RE: Appeal of Certificate of Appropriateness:
Hearing – October 3, 2022
4512-4518 Sycamore St., Case No. CA212-354(RD)

**4512-4518 SYCAMORE
STREET
APPEAL
CA212-354(RD)**

**City Plan Commission
Hearing
01/05/2023**

4512 – 4518 Sycamore Street CA212-354(RD)

Duplex Number 2

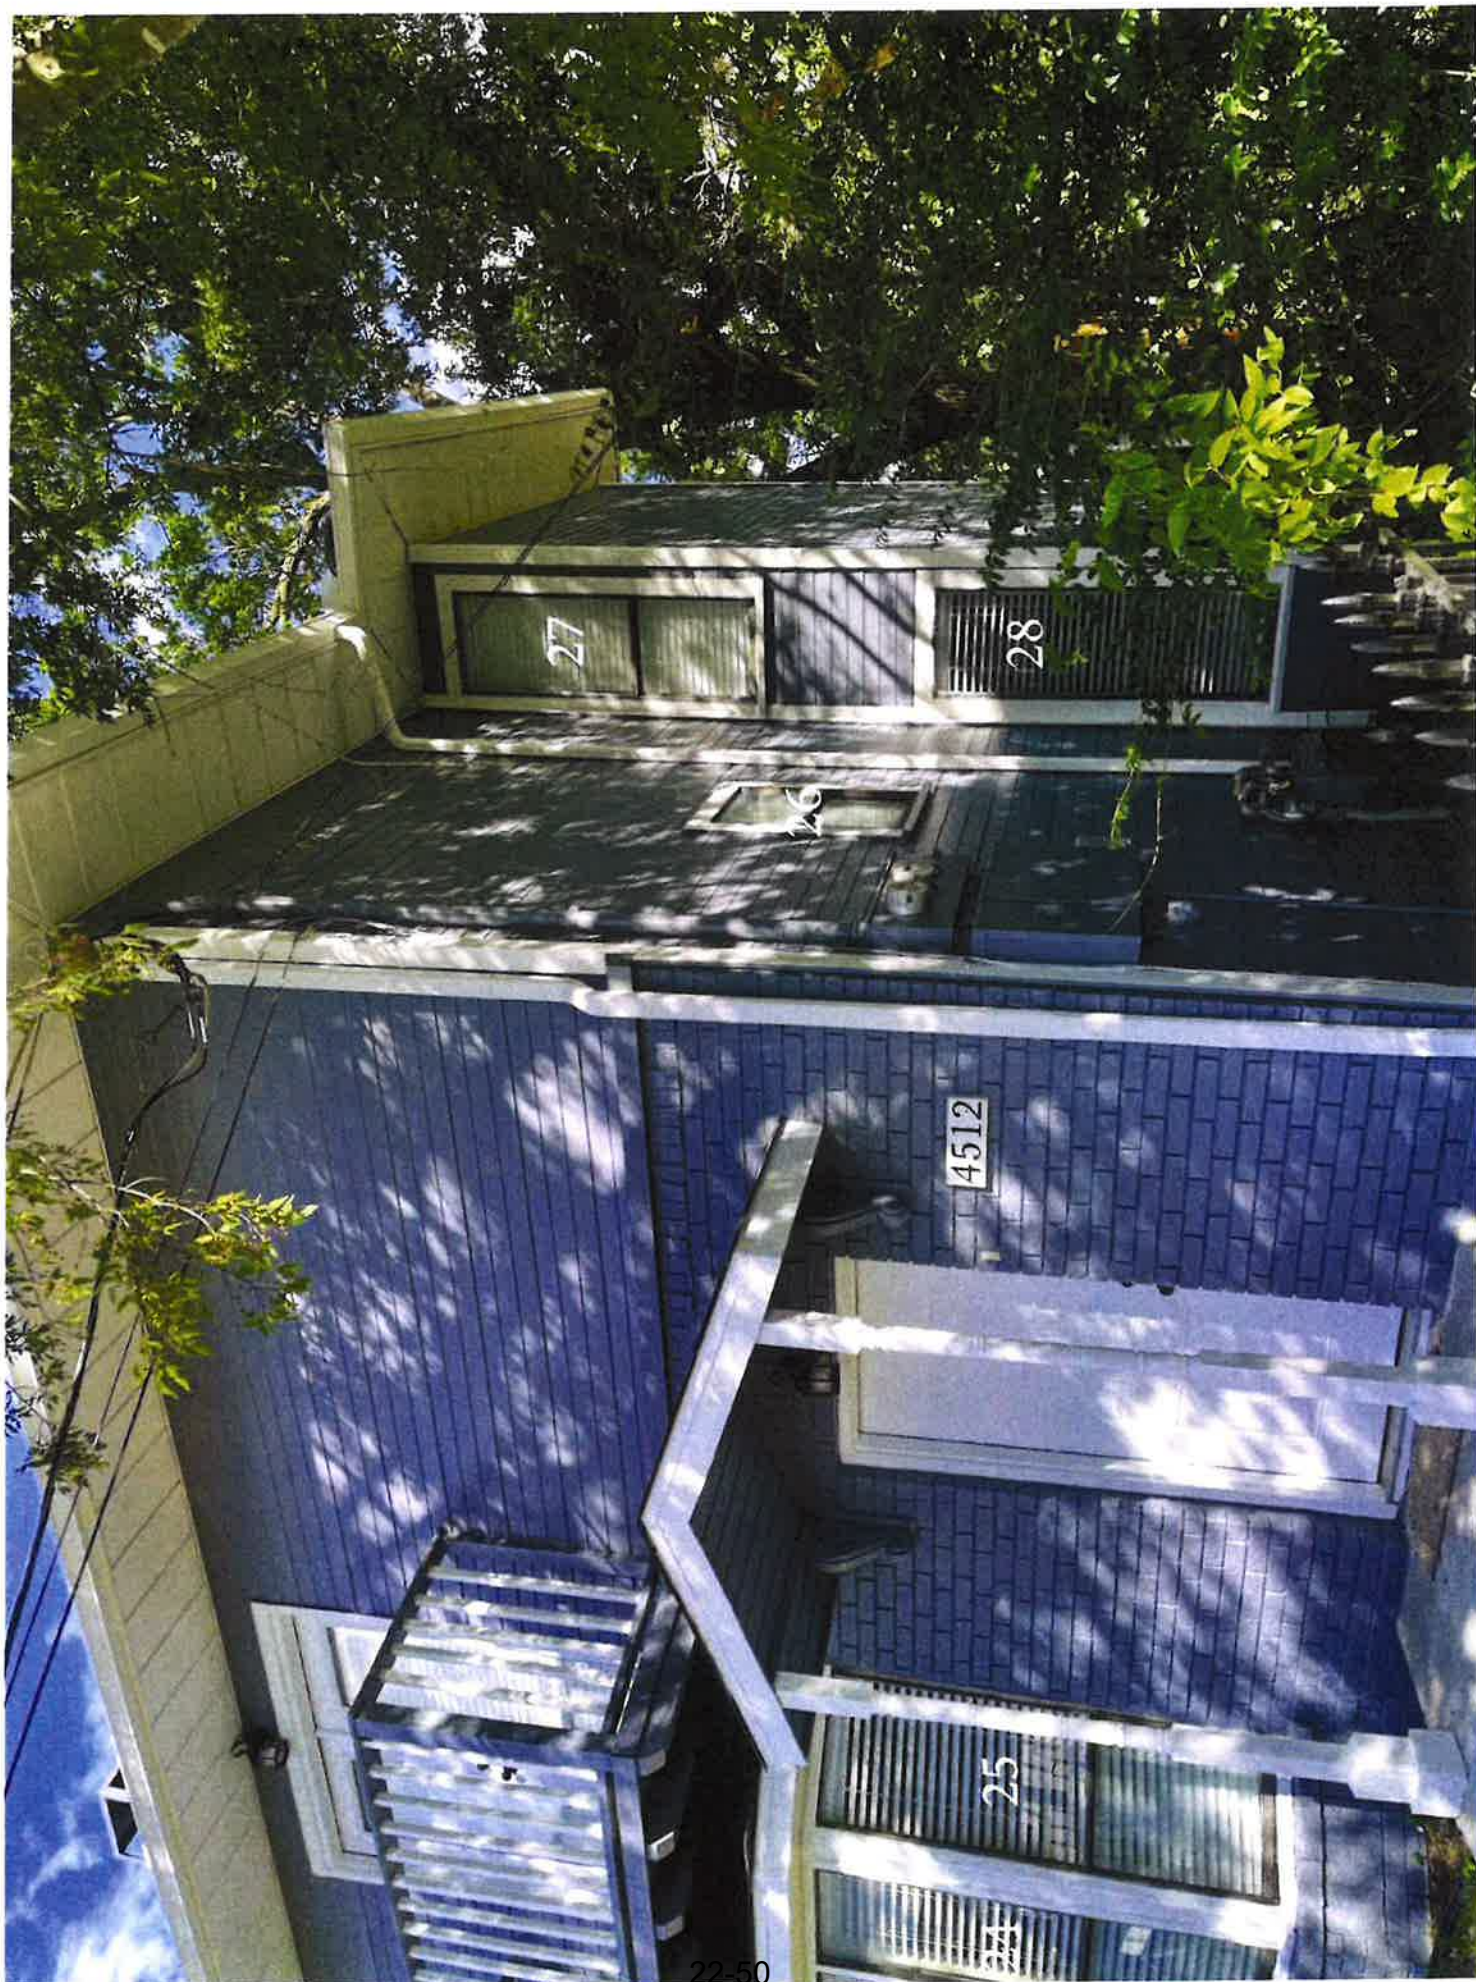
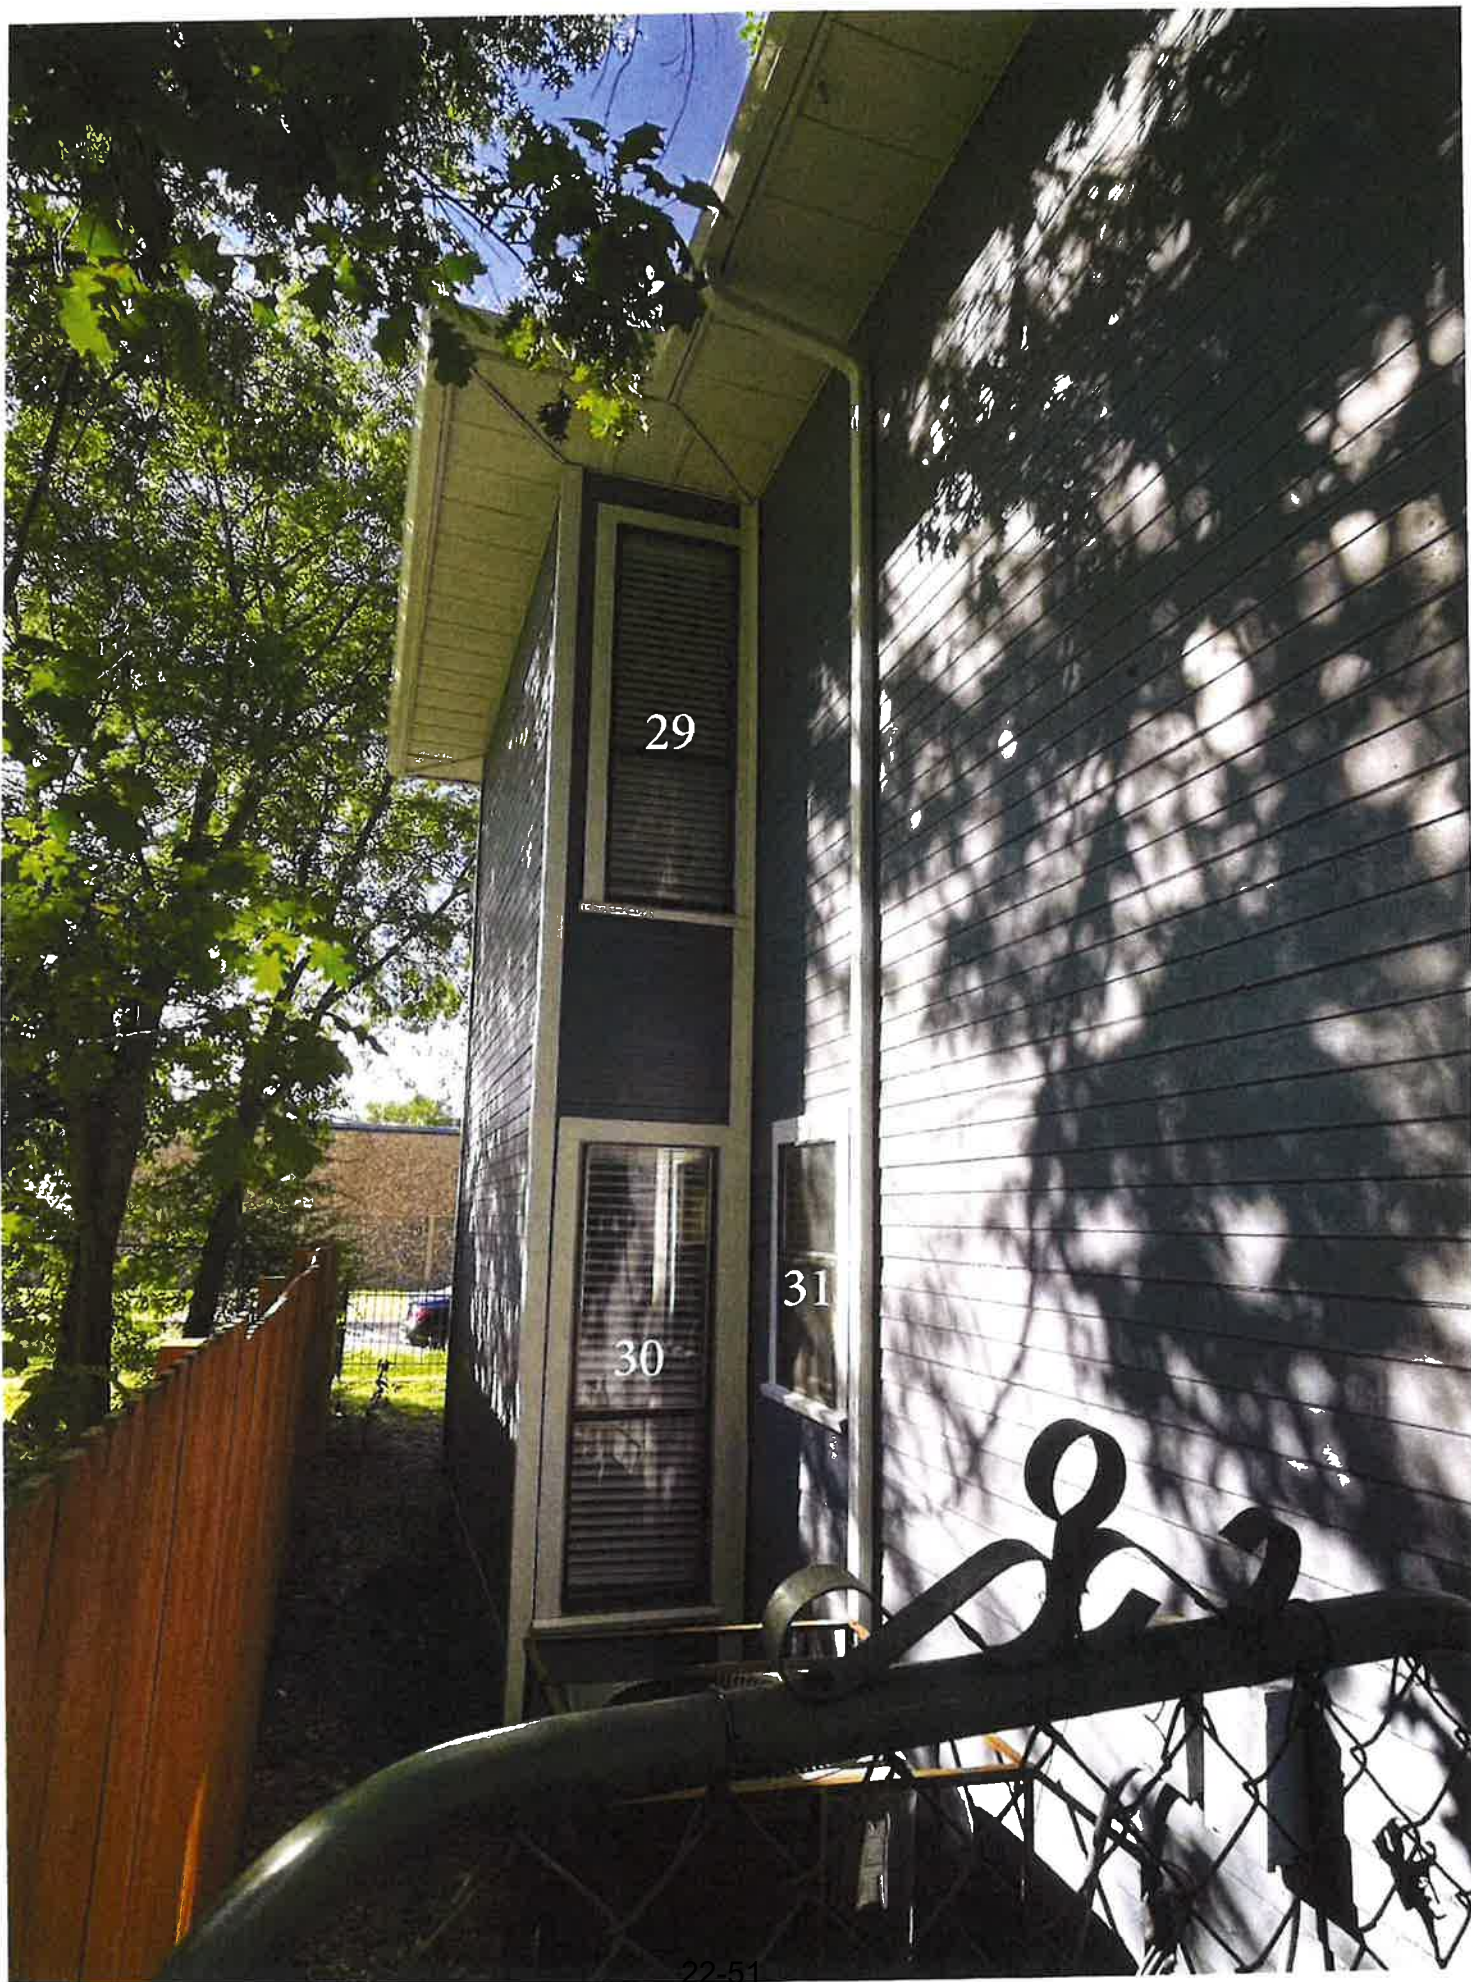
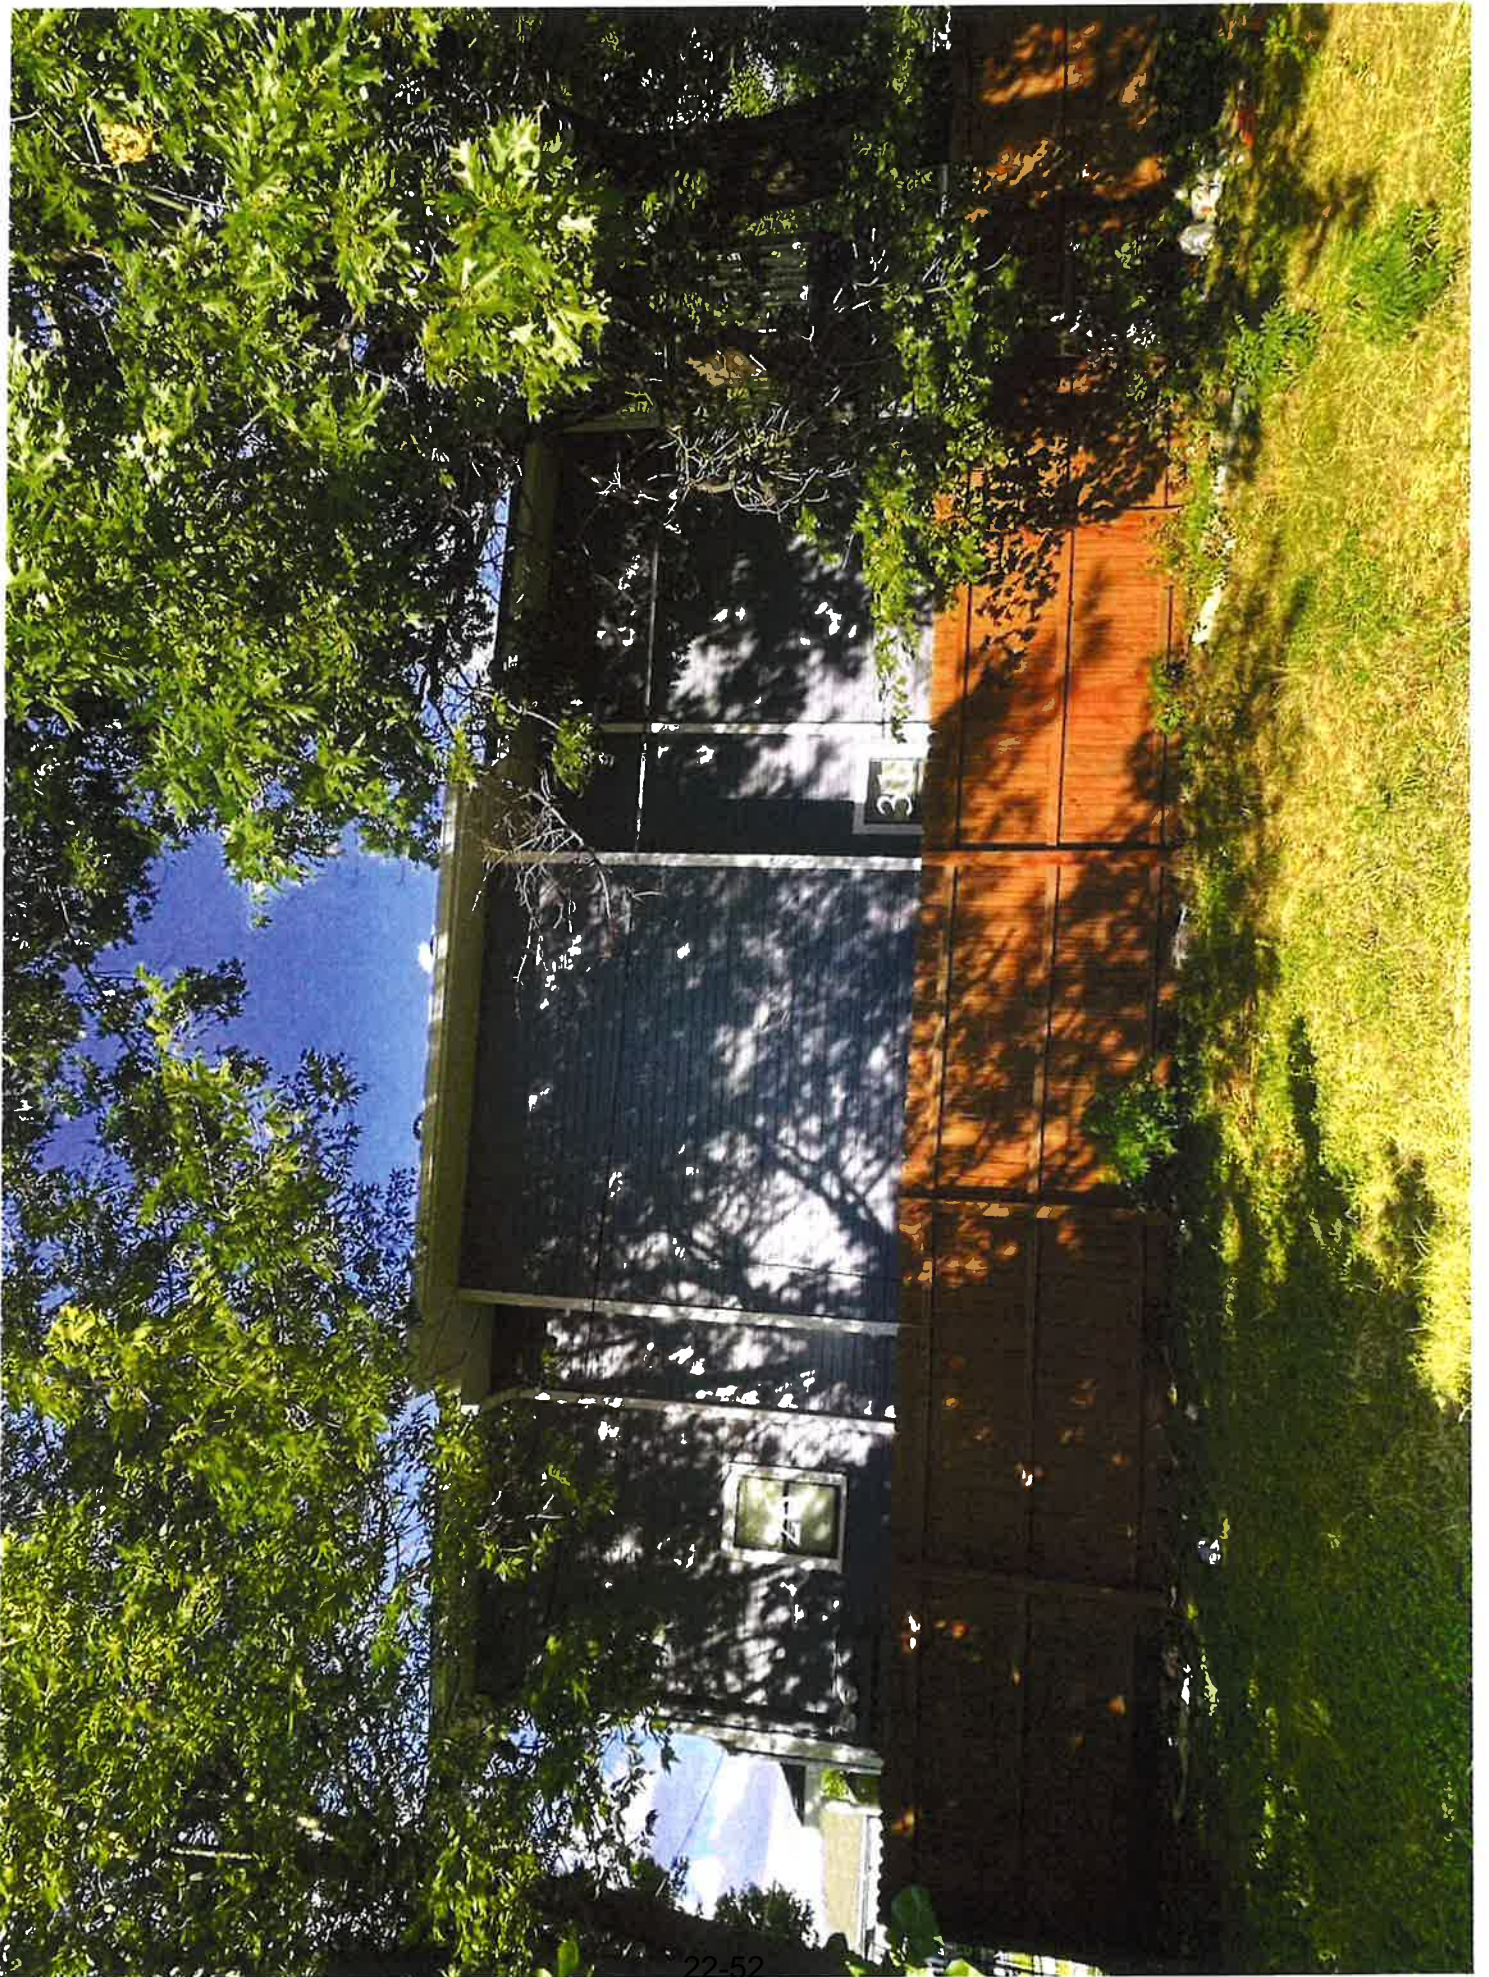
2 don't see on the detail that's provided
3 that -- it looks like the meeting sash
4 is the same dimension as the side rail
5 sashes and the top rail sashes. I don't
6 see a difference between your meeting
7 rail sash. That's a very prominent
8 feature on historical windows, interior
9 windows, and I don't see that.

14 COMMISSIONER CUMMINGS: No, I'm
15 talking about the bottom sash. There's
16 also indications of differences on the
17 thickness of the meeting sash, but let's
18 just talk about the bottom sash. What's
19 your dimension on your bottom sash? And
20 I also don't see a sill detail that was
21 called out, and you had three choices on
22 the windowsills.

11 COMMISSIONER CUMMINGS: Correct.
12 It doesn't seem like there's a
13 difference between the bottom sash
14 dimension and the side dimension.

5. That the request for a Certificate of Appropriateness to replace wood windows with wood composite windows be **denied**. Wood composition windows are not wood, and these windows would have an adverse effect on the historic district. Work is not consistent with 51A-4.501(g)(6)(c)(ii) for non-contributing structures. Proposed work is not compatible with the historic district.

SASH - EXPLODED VIEW

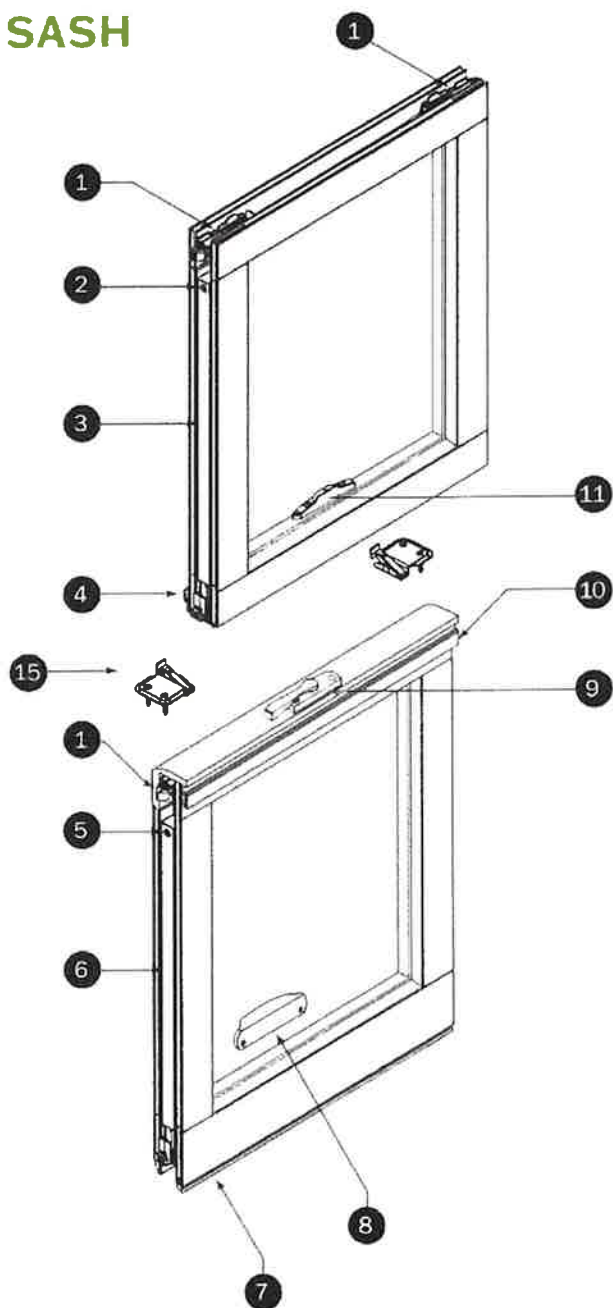
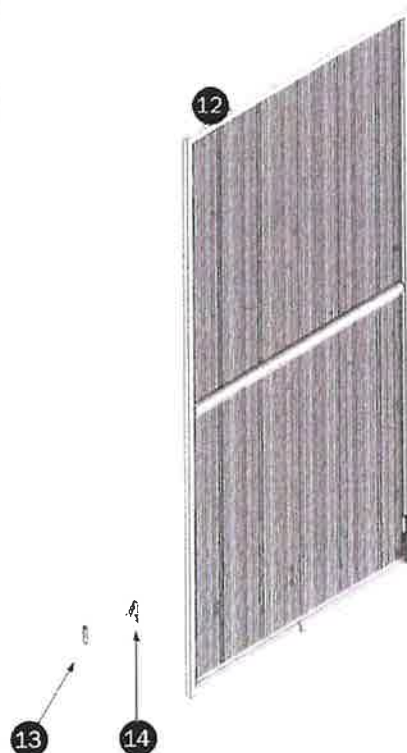
11 COMMISSIONER ANDERSON: Second
12 question is the wood composite windows.
13 This historic district requires wood
14 windows. We do not allow things such as
15 Hardie Board because it's an imitation
16 material. So I'd like to get more
17 information on what wood composite
18 windows are and how they are to be used
19 in this historic district.
